Eastern Creek Energy from Waste Facility – SSD 6236

The Environmental Impact Assessment (EIS) for SSD 6236 submitted by the applicant has not sufficiently addressed numerous important matters adequately.

BOM- GDE & IDE Mapping

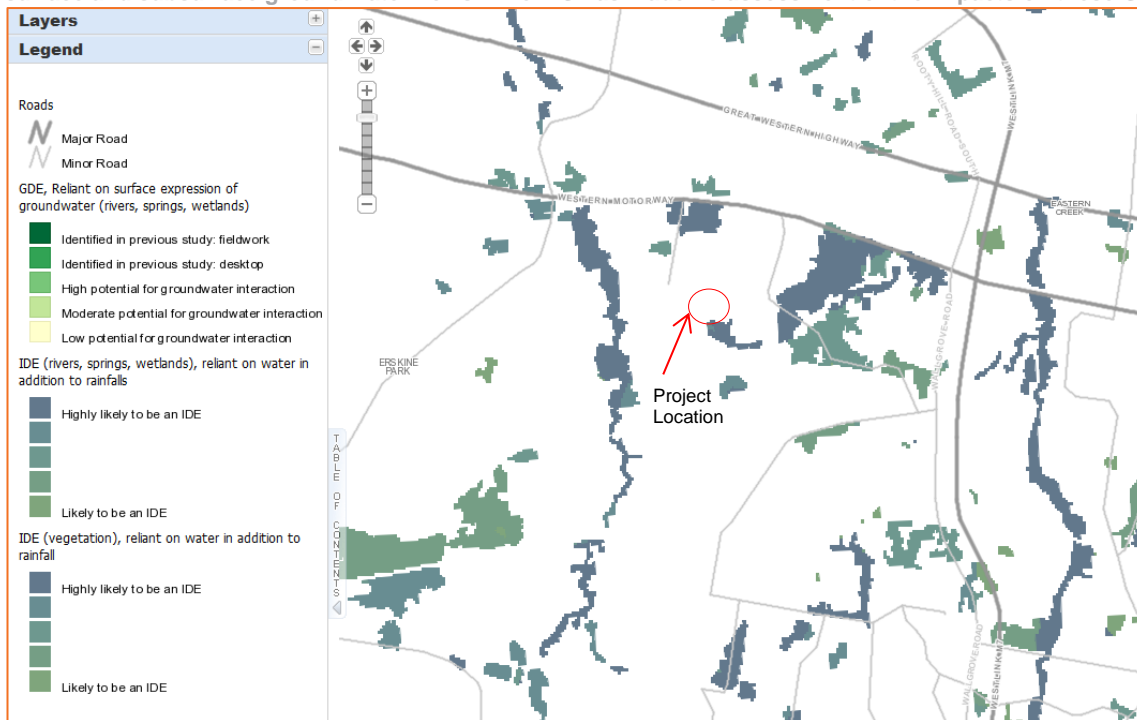
It is evident that the proposed invert of the waste bunker will be significantly lower than the existing groundwater levels. There is insufficient detail provided in the EIS on the nature of the waste bunker to adequately assess true impacts on the groundwater system that flows through to Ropes Creek and potential GDEs and IDEs. According to the BOM GDE and IDE mapping (below) the area in question is highly likely to have ground water interaction and have GDEs and/or IDEs reliant on surface and subsurface ground water flows. The EIS has made no assessment of the impacts on these GDEs and IDEs.
